TRUCK SUSPENSION

**SERVICE
BULLETIN**

AD Series

Equalizer Beam

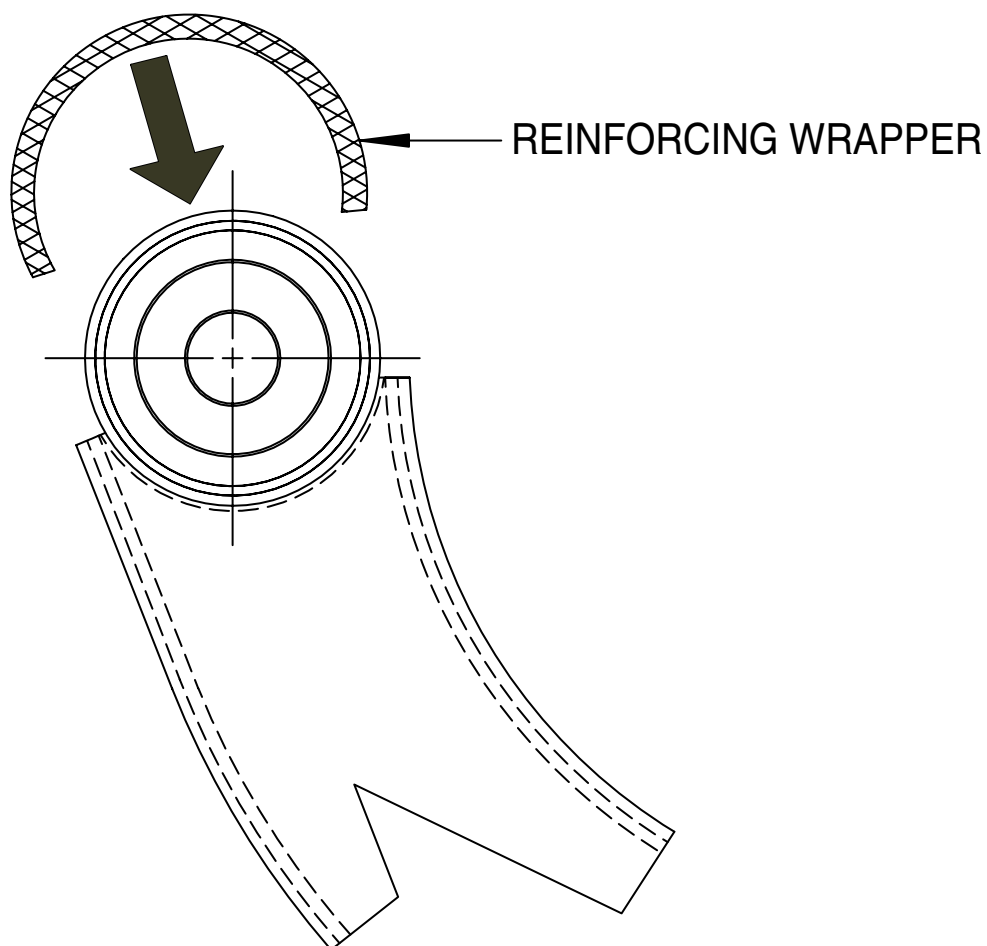
Effective immediately, all equalizer beams fitted to "AD SERIES" suspension will be supplied with a reinforcing wrapper fitted to the pivot eye of the beam. This applies to both new suspension kits and spare parts.

This change is to give greater durability of the beam when operating in extreme conditions.

The upgraded beam can be easily identified as shown below.

Part numbers for beams will not change as only the upgraded beam will be available. Should an equalizer beam be replaced in the field, only the upgraded beam should be fitted
